Fulham Solar Farm | Section 72 Amendment & Endorsement Request

Project No: 35039

DTP reference:
PA2101365-1

Figure 3-1 Amended Site Layout Plan

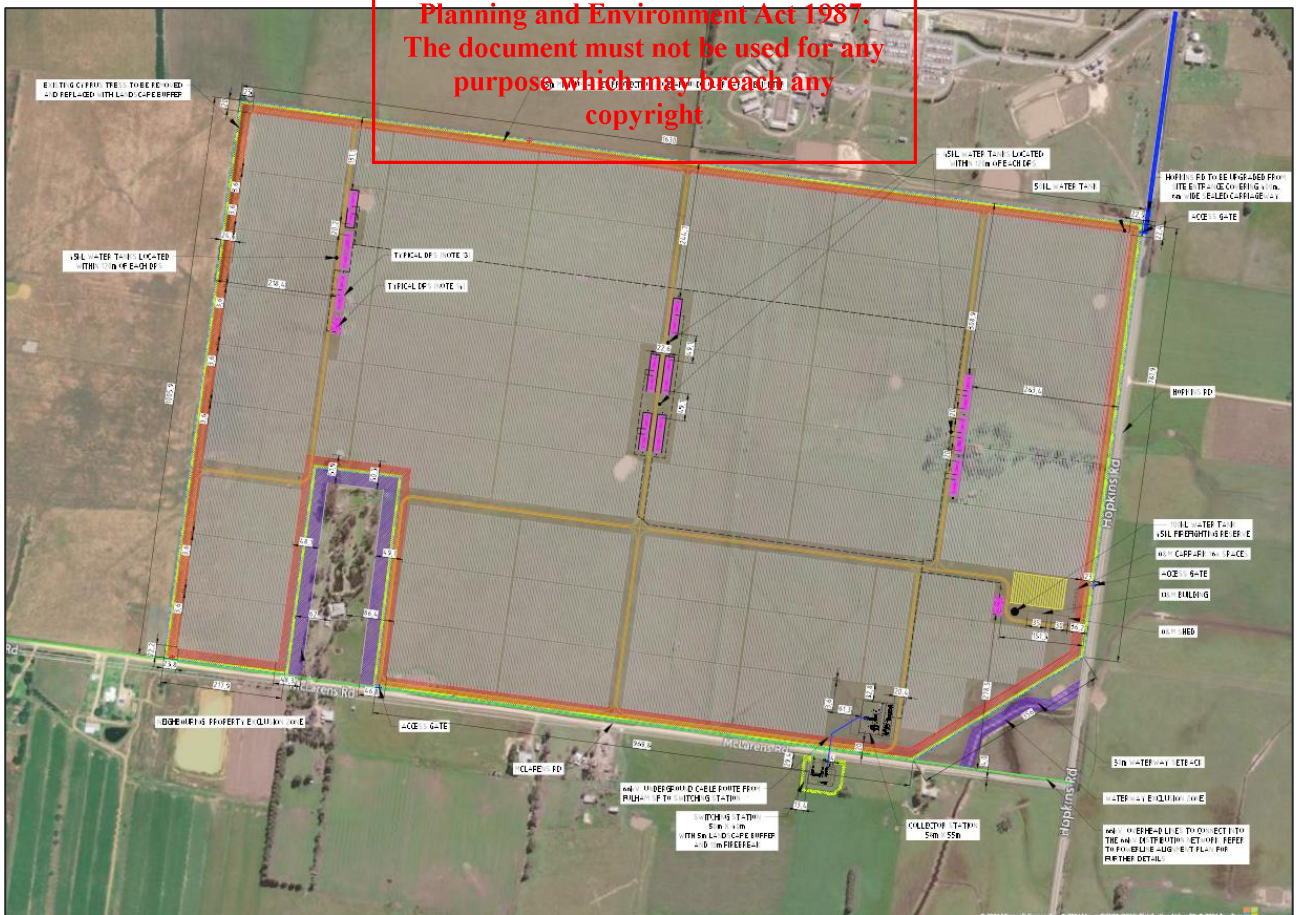
- Amend the address of the permit to include 913 Settlement Road, Fulham and McLaren's Road Reserve
- Amend the decision plans, including:
 - Amended solar array layout
 - Amended access track location
 - Property setbacks
 - System Specifications
 - Powerline alignment
 - Relocate the Switching Station to 913 Settlement Road.
 - Relocate substation
 - Changes required by permit condition
- Amend the endorsed Landscape Plan including:
 - Changes to the planting schedule
 - Include the land at 913 Settlement Road, Fulham
 - Staging plan amended
 - Minor changes to the location of the buffer
- Delete permit conditions 43, 44(g), 49, 50
- Amend permit condition 1(c), 32, 51 and 62

Figure 3-2 Proposed Distributed Power Station – Individual

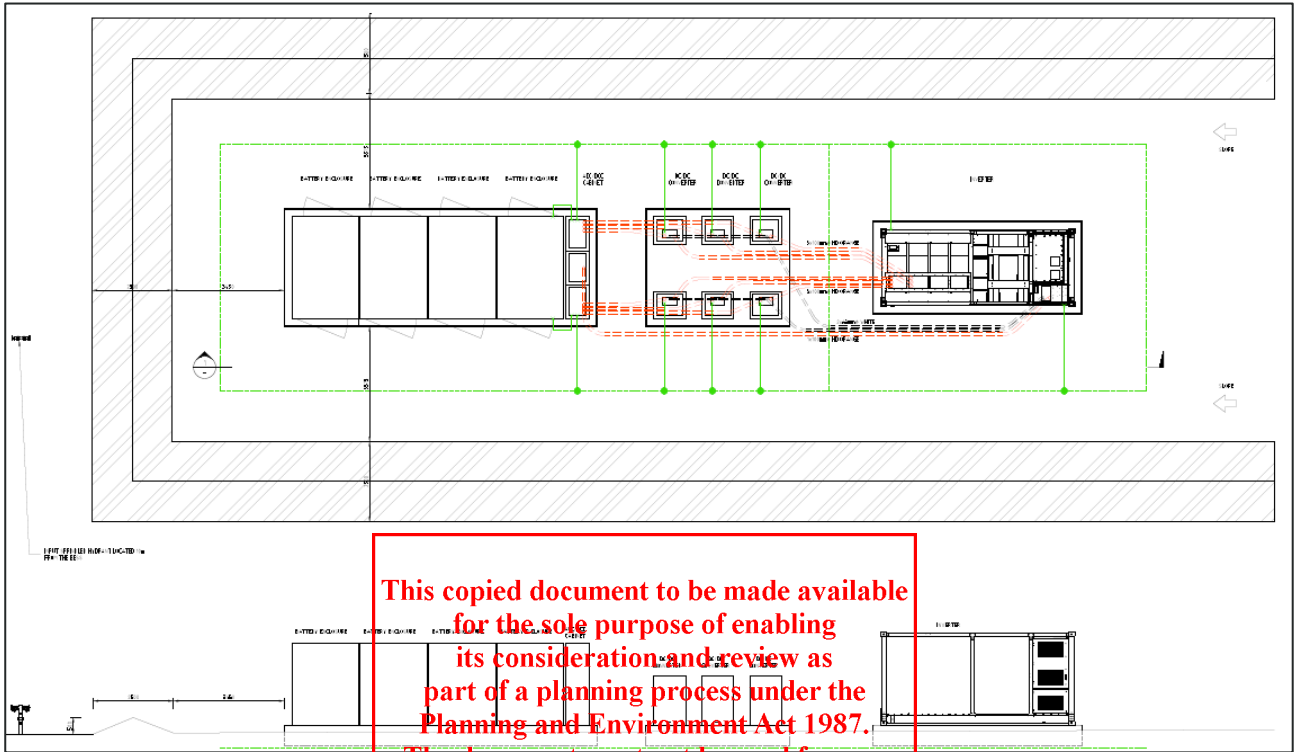
The BESS arrangement (23 in total) shown on the decision plans comprising of three (3) 12.2m x 2.5m batteries, an 8m x 4m shed containing eight (8) convertors, and a 6 x 2.4m inverter, these will be replaced by 24 Distributed Power Stations (DPS). The DPS's will contain three (3) batteries, six (6) convertors, and one (1) inverter and comprise the following dimensions, 28.87L x 7.67W.

The DPS are presented either individually (as per **Figure 3-2**) or coupled (as per **Figure 3-3**). Earthen bunds (discussed in greater detail below and within the Risk Management Plan) perimeter each DPS, and will have capacity to contain up to 45kL of firewater runoff per individual DPS.

Figure 3-6 Decision Plans Alignment

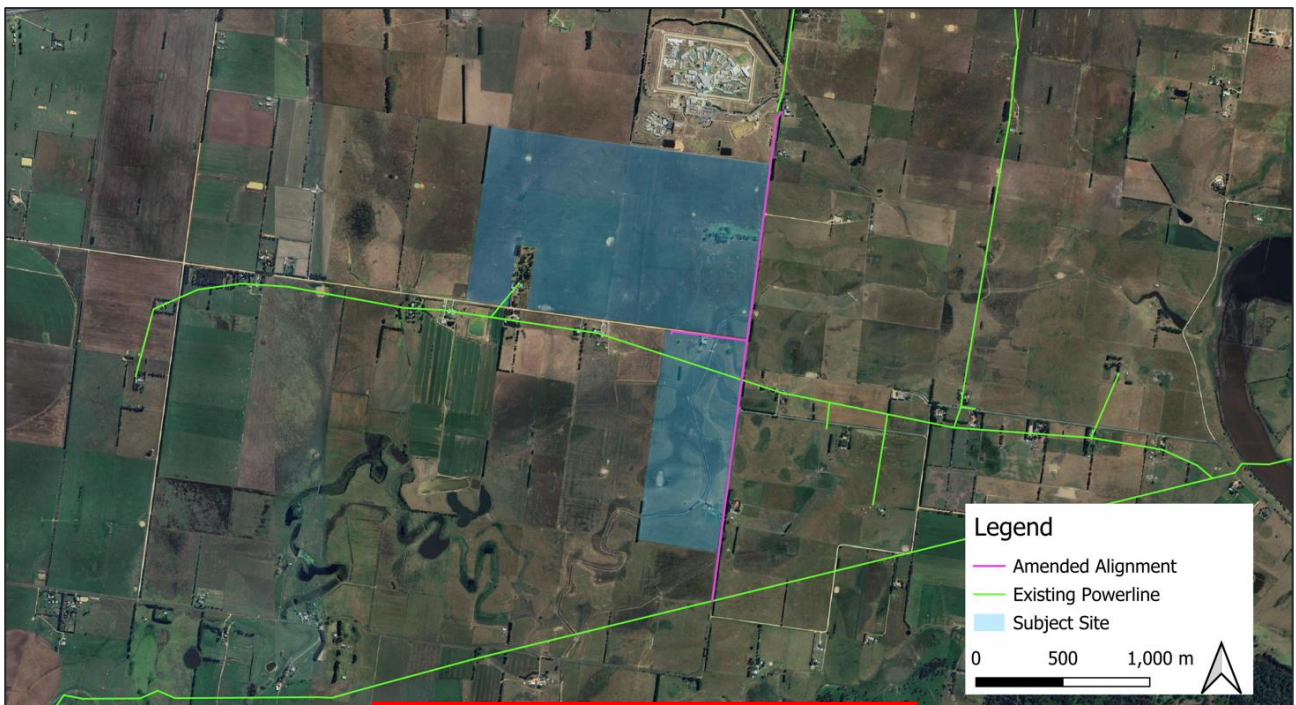
The project will continue to utilise the existing 66KV powerline, located approximately 1.5km south of the subject site, as its point of connection to the National Electricity Market (NEM). The relocation of the switching station as well as direction from AusNet has required changes to the powerline alignment and location of power poles. These changes include:

- Power poles and powerlines to be installed along McLarens Road connecting the switching station to the alignment along Hopkins/Settlement Road.
- Removal of powerline intersecting the eastern half of the subject site (providing energy to the dwelling).
- Powerline to continue north along Hopkins/Settlement Road to 111 Hopkins Road, Fulham.

Changes to the grid connection alignment, best demonstrated in **Figure 3-6 Decision Plans Alignment** and **Figure 3-7 Amended Alignment**, are the result of:

Figure 3-8 Switching Station

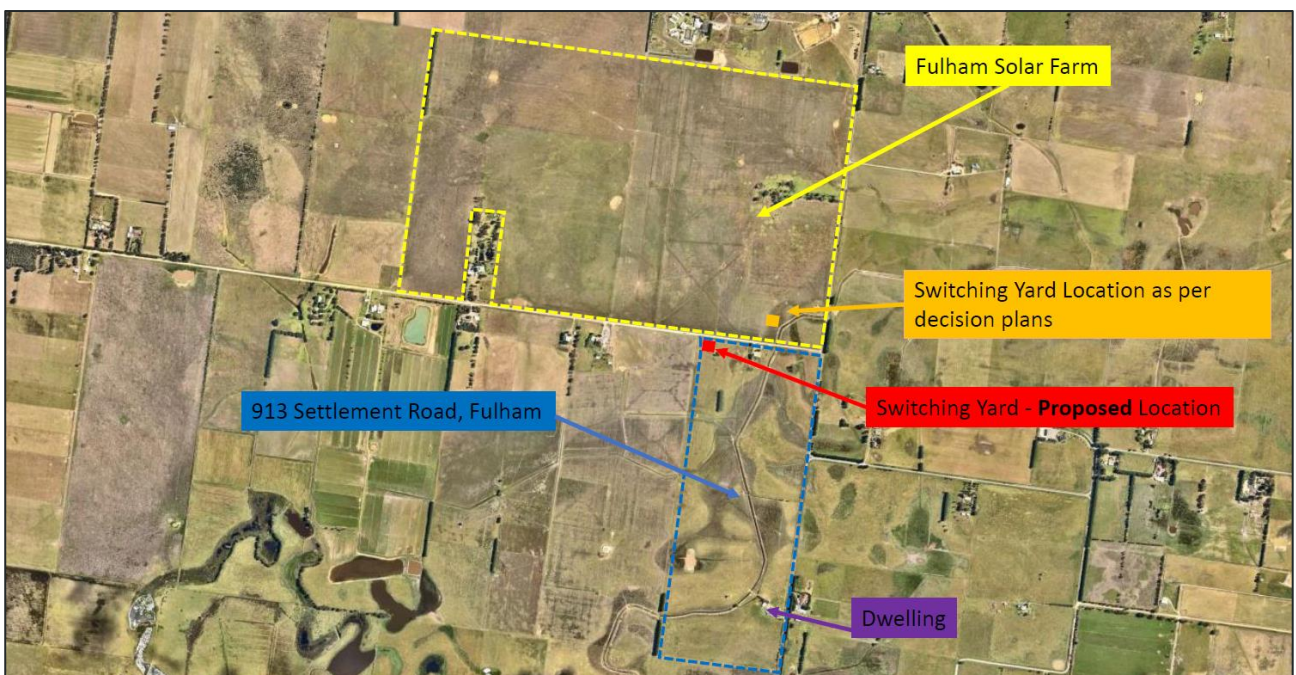
The switching station, currently shown on the decision plans in the south east corner of the site, is to be moved to the north west corner of the land located to the south of 913 Settlement Road as required by AusNet (further discussed within Section 5.2).

The Switching Station, an AusNet owned and operated asset, will occupy a smaller footprint when compared to the decision plans (reduced from 50m x 50m to 56m x 35m), and include a 5-metre-wide landscape buffer to provide visual screening, and a 10 metre wide non-combustible firebreak.

Figure 3-9 Switching Station Landscape Arrangement (913 Settlement Road)

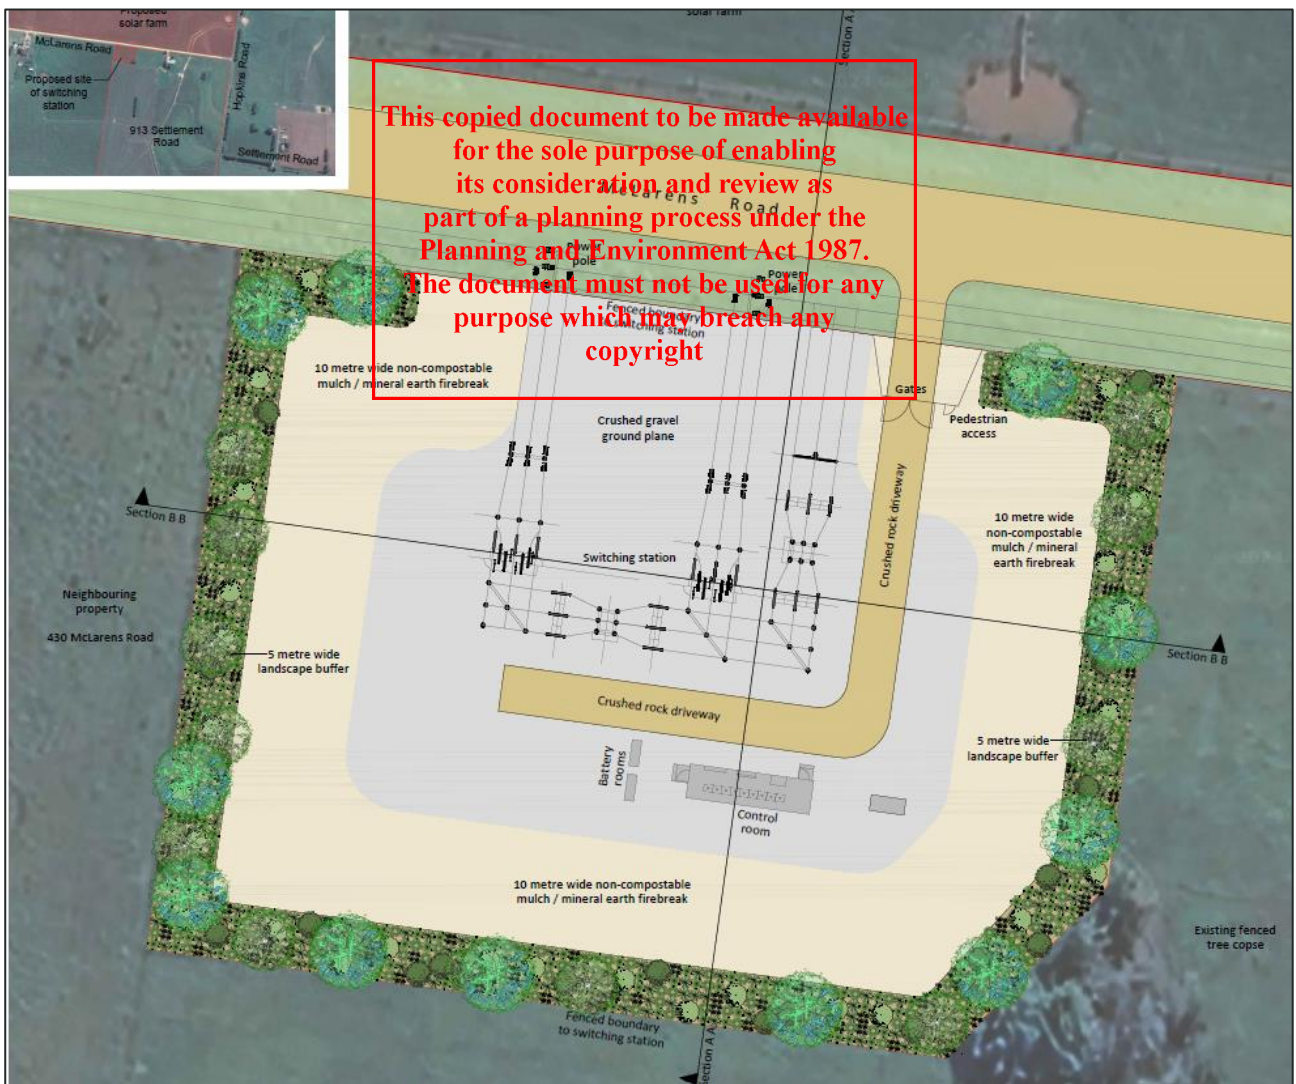
It is proposed to amend the Landscape Plan, last endorsed by DTP on 20 July 2023, to include the land at 913 Settlement Road, Fulham. A 5-metre-wide landscape buffer will run on the outer side of the firebreak around the periphery of the switching station and will include the same planting schedule as the main site.

The planting schedule has been amended following discussions with the CFA and the preparation of the Risk Management Plan. Changes to the planting schedule include:

- Replace Black Sheoak Tree with Golden Wattle
- Reduction in tree quantity
- Height of maturity of the Burgan shrub reduced from a maximum of 5m to 2m. A notation has also been added stating 'shrubs exceeding 2 metres growth will be pruned accordingly'.

Figure 5-3 Acoustic Barrier Locations and Heights

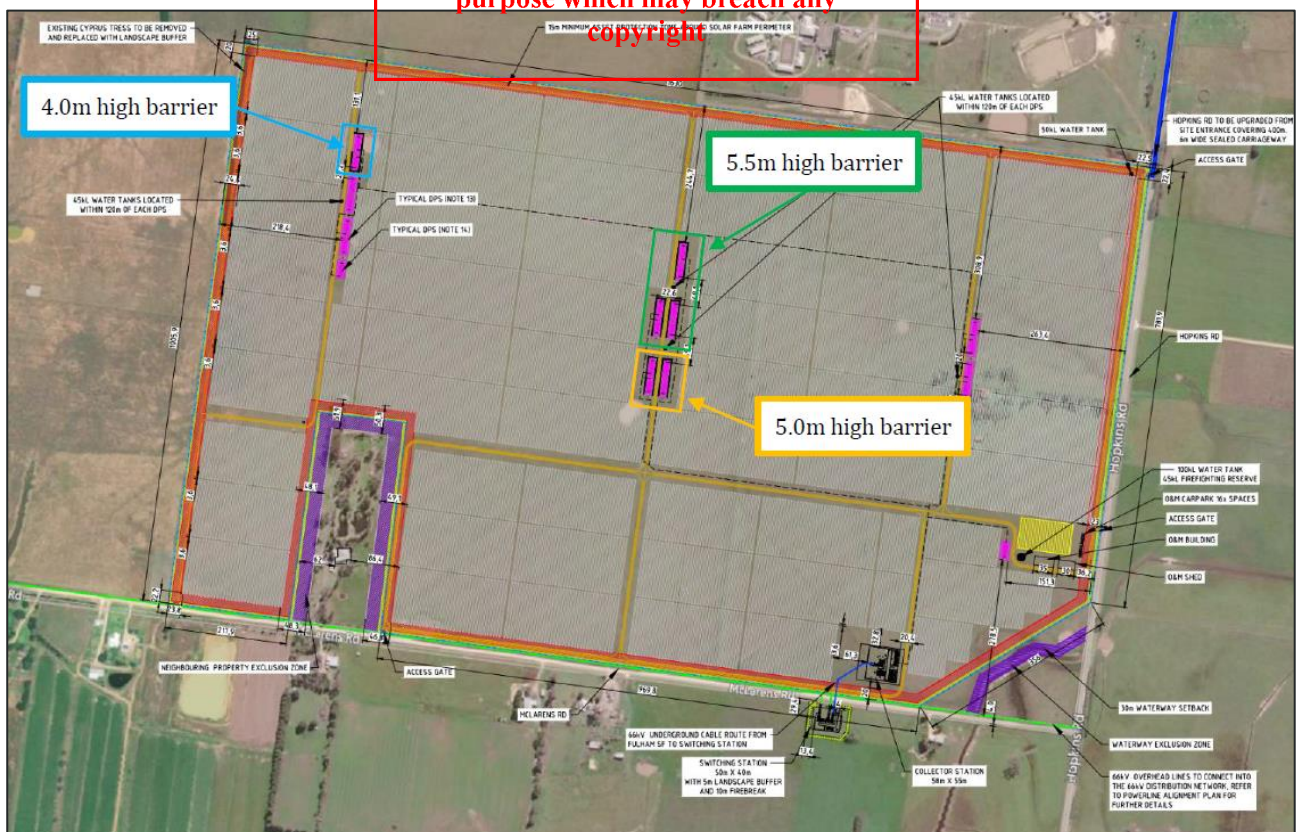
The strategy was revised during detailed design, with a targeted approach implemented. This has limited the need for acoustic strategies to just the central cluster of DPS's (10) and the two (2) DPS's in the north west. As discussed within the Acoustic Assessment, acoustic barriers in the north west will be limited to 4.0 metres in height whilst centrally, these barriers will range from 5.0-5.5 metres in height (refer **Figure 5-3** for location).
